Project Name	Ickleford Mill, Ickleford
Subject	Off-Site Highways Works Note
Reference	25232
Date	February 2026

ROAD SAFETY AUDIT REPORT

Project: Ickleford Mill, Arlesey Road, Ickleford, Hertfordshire
Proposed Highway Works

Project Name	Ickleford Mill, Ickleford
Subject	Designer's Response to Stage 1 Road Safety Audit
Reference	25232/N03
Date	February 2026

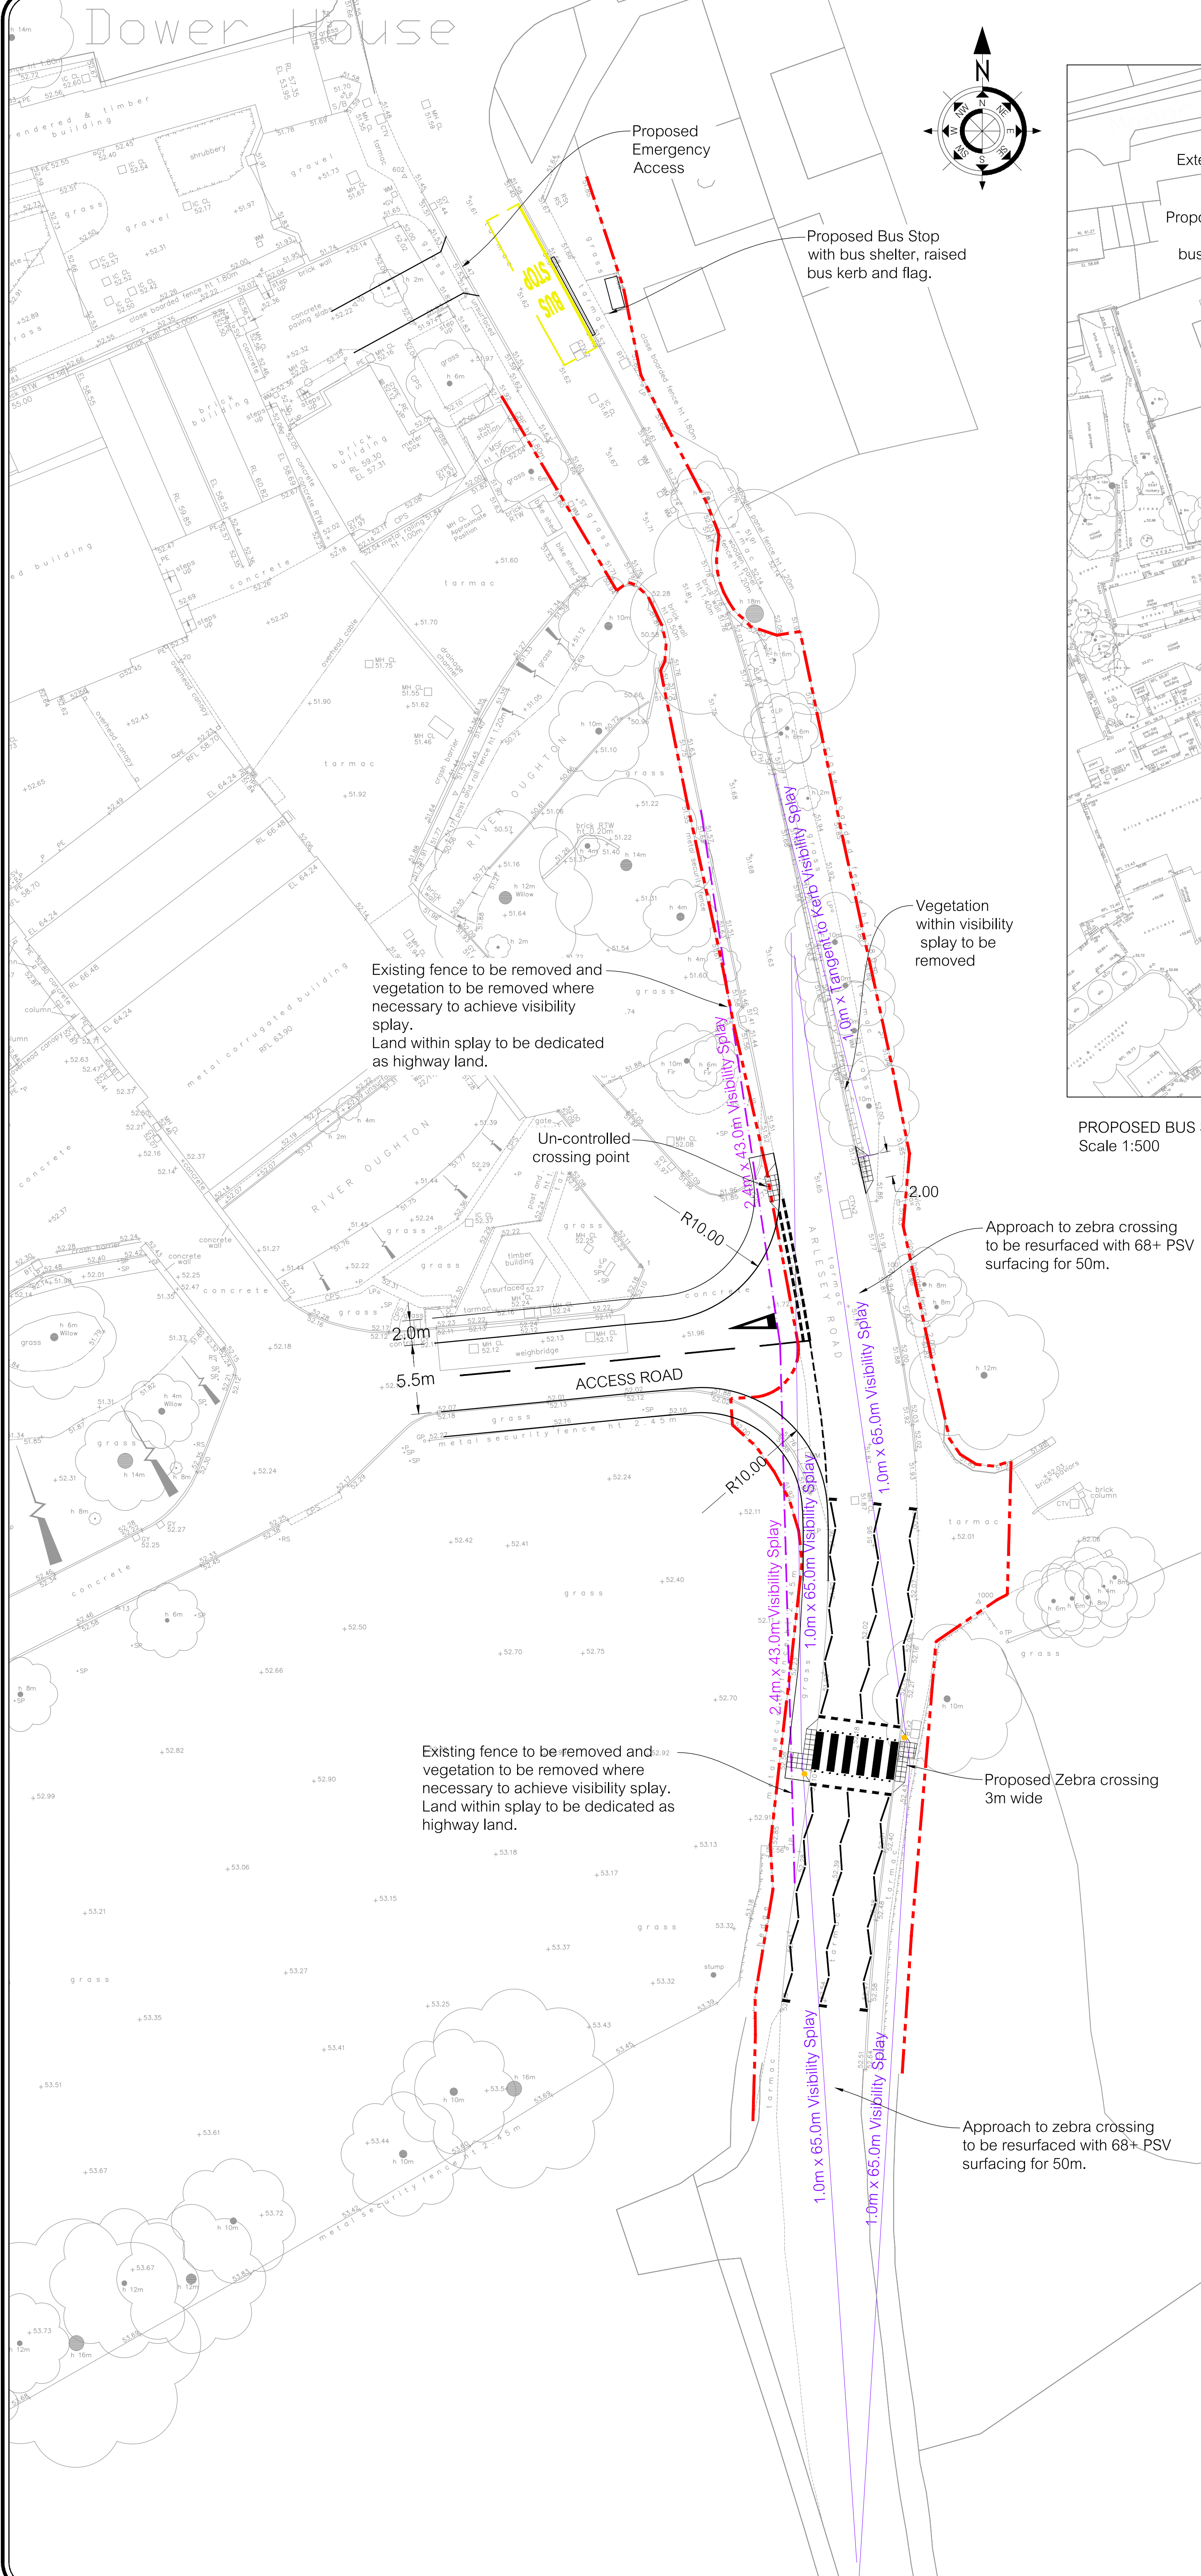
- 1.4.3 The first relates to the forward visibility to the proposed traffic calming measure. Forward visibility splays have been added to the drawing which, considering the barrier structure at the river crossing as a constraint, results in forward visibility below the usual application of 30 mph distances. However, this situation already exists.

- 1.4.4 Drivers are observed to slow towards the pinch point before accelerating through once they are satisfied the ahead movement is clear. The proposal seeks to formalise this by prioritising movement away from the village. The drawing shows the achievable visibility which is considered to be appropriate for the situation on Arlesey Road.

- 1.4.5 The Stage 1 Road Safety Audit also raised concerns relating to the location of the crossing to the rear of the bus stop cage. This issue highlighted suggested limited visibility in situations where pedestrians cross whilst a bus is at the bus stop.

Drawing Number:
E3631/700/E

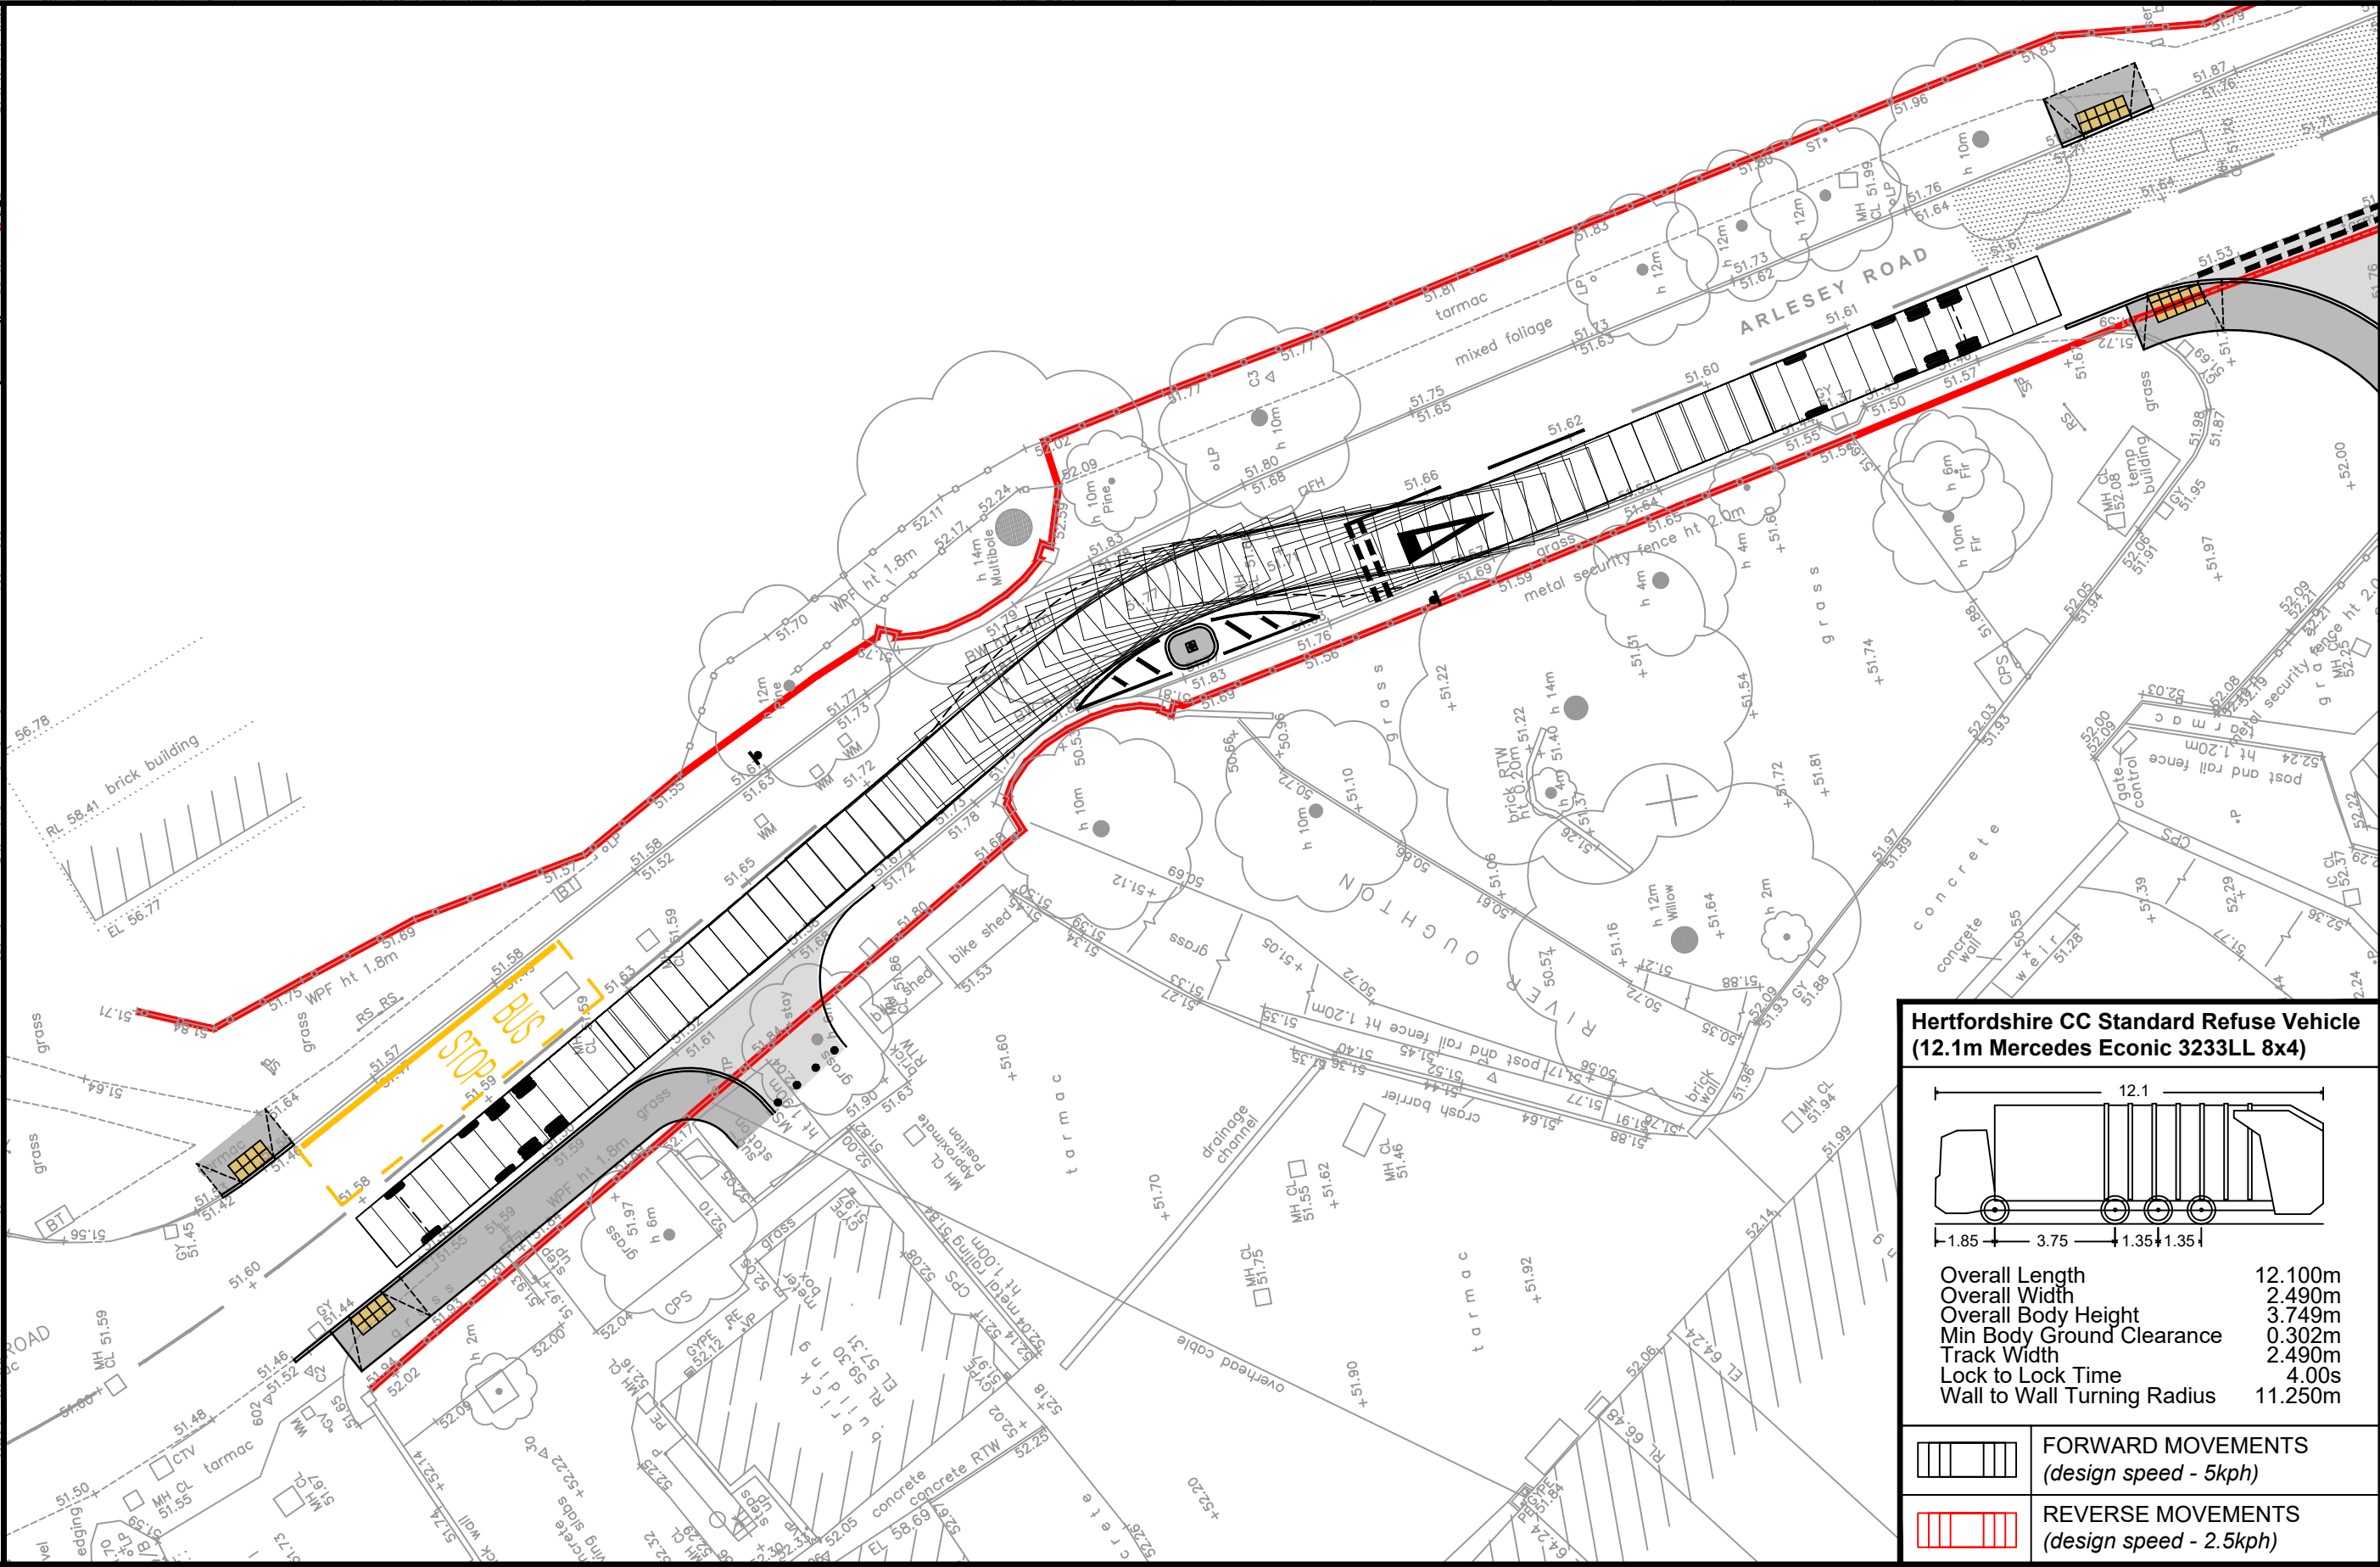
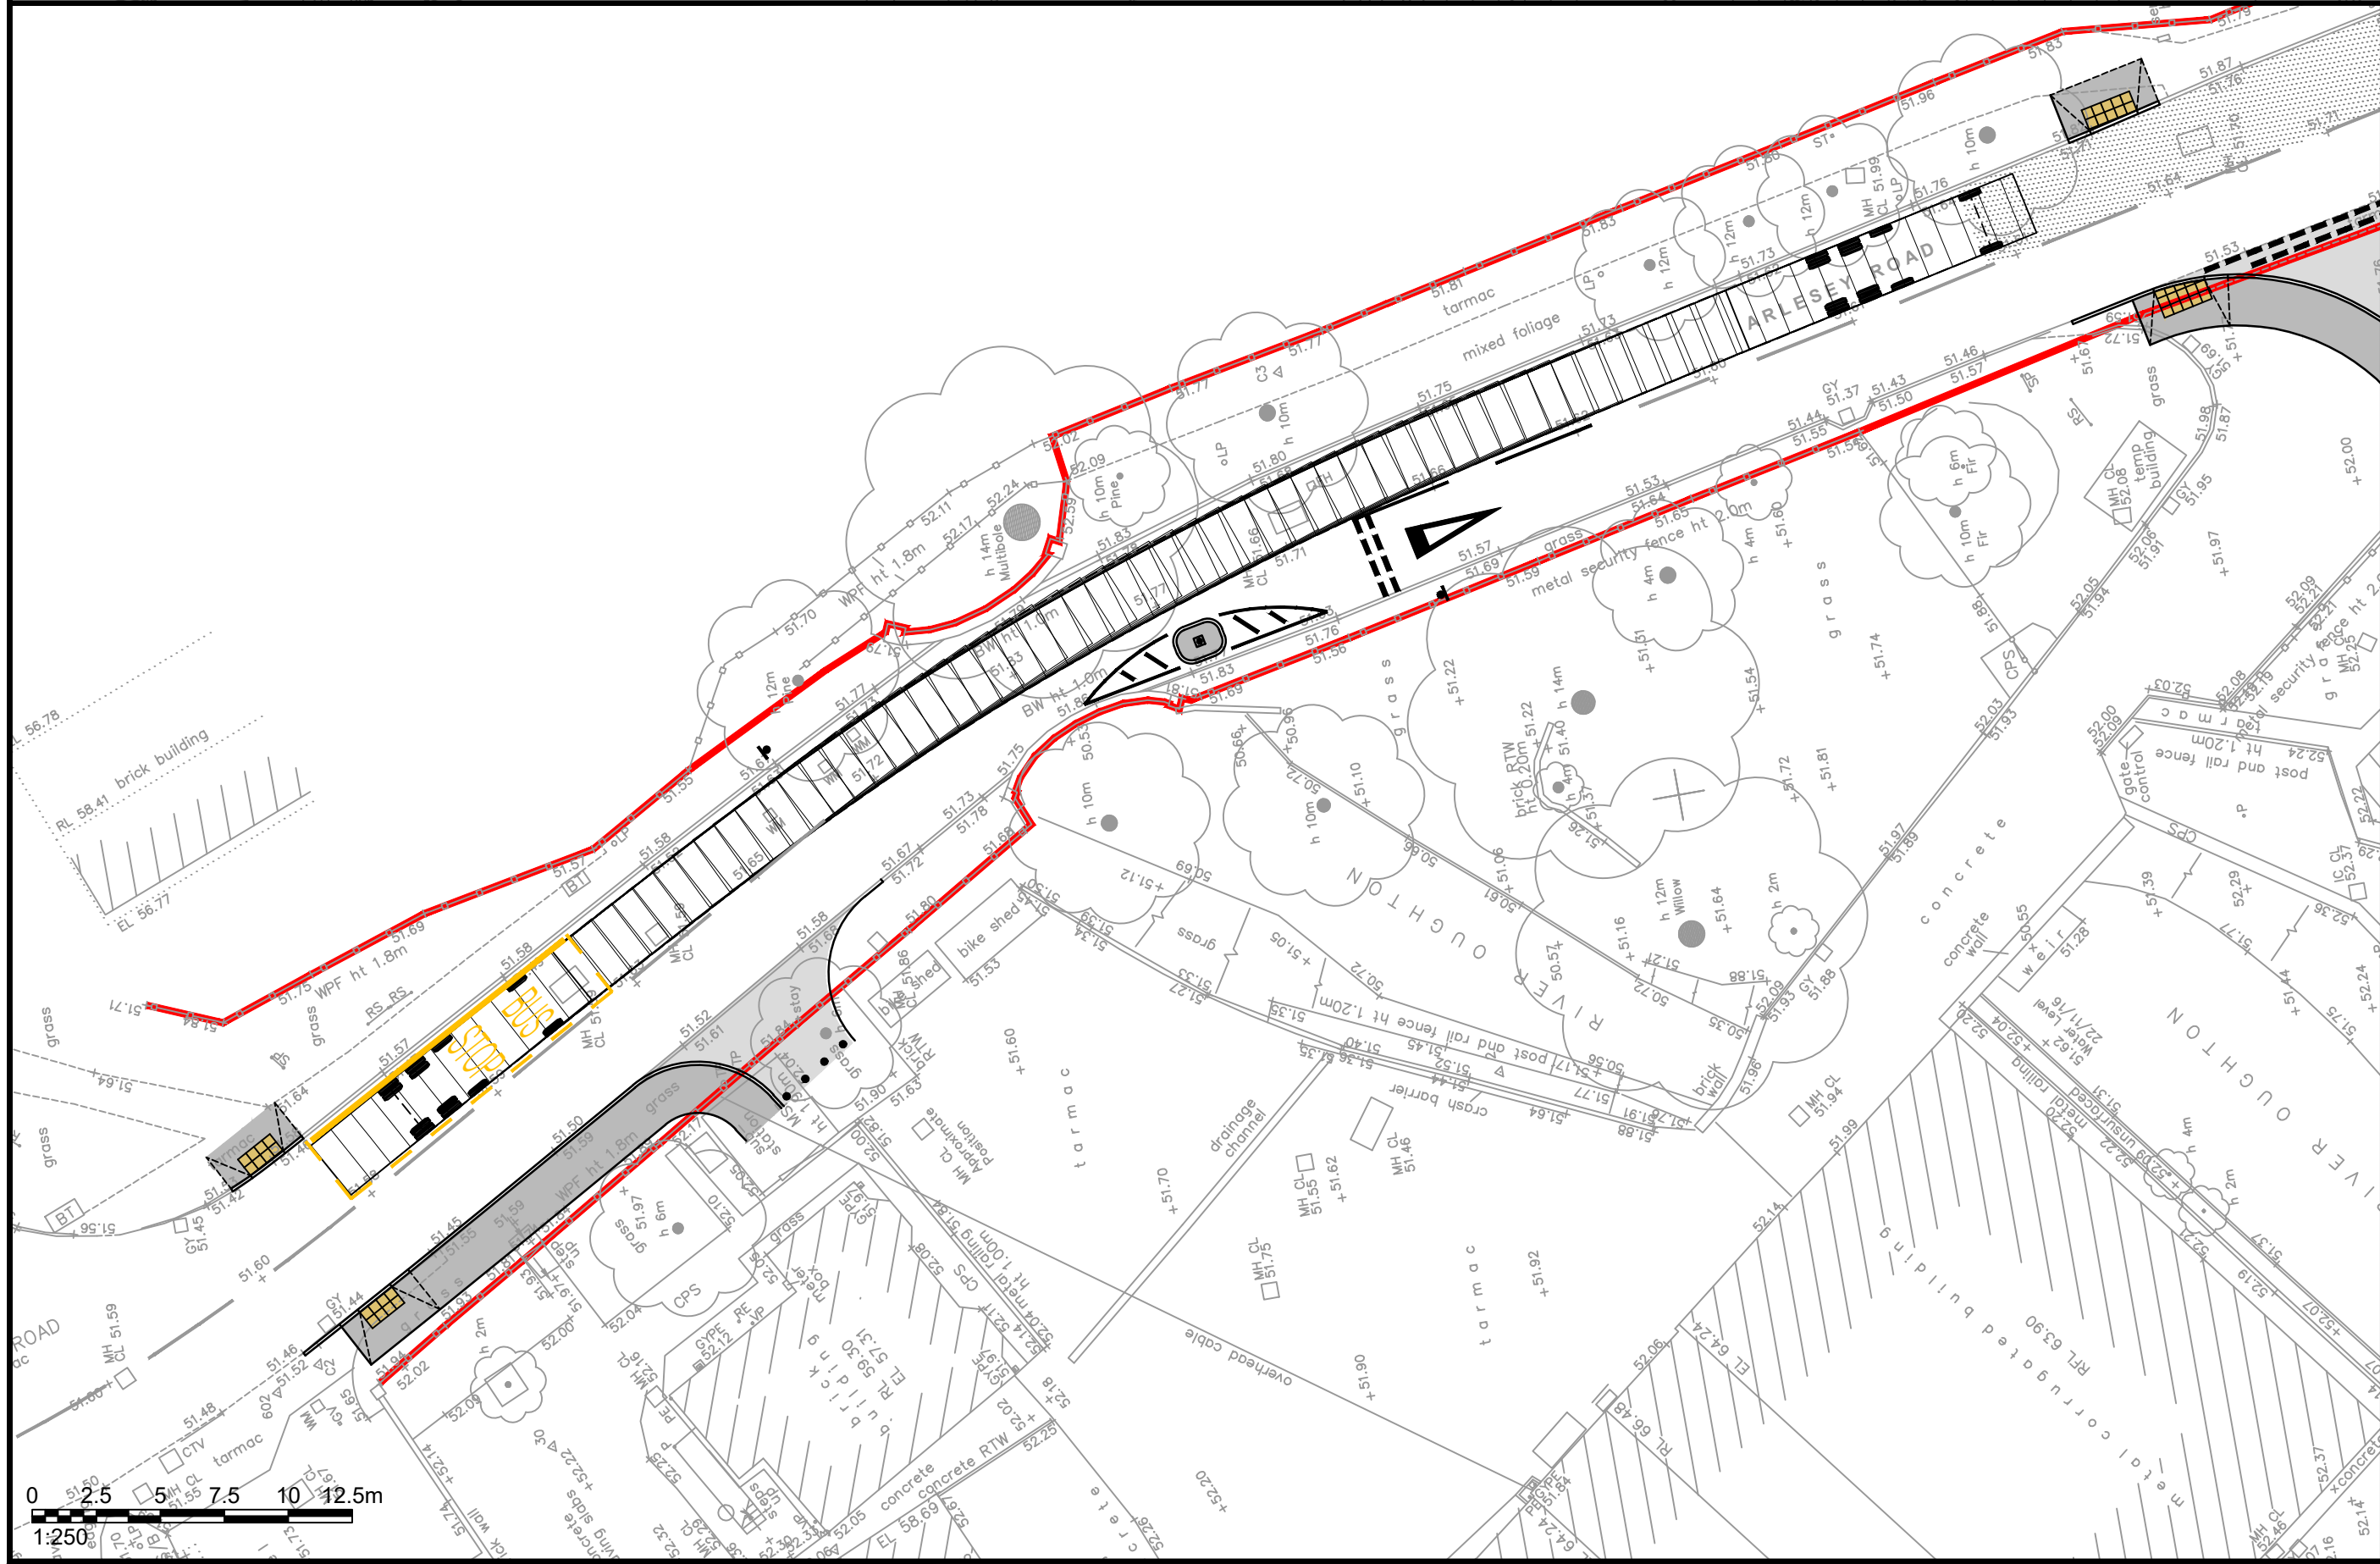
- 1.2.3 This note will be submitted in conjunction with a Section 73 application, which is being submitted alongside the reserved matters application.
- 1.2.4 It is noted that the consented scheme did not provide any details for how pedestrians might access the emergency access. No restrictions to prevent access were put forward and crossing facilities would likely be required as part of further detailed design stages.

- 1.2.5 It is also noted that no Stage 1 Road Safety Audit supported the proposals at the outline stage.
- 1.2.6 The principle of the changes to the access have been discussed with the highway authority. No in-principle objections were raised but a request for a Stage 1 Road Safety Audit to support the proposals was made.

- 1.3.2 The site layout requires the relocation of the emergency access approximately 15 metres to the south of the position shown in the approved drawing. This is required in order to effectively use the site and provide homes within an appropriate street scene.
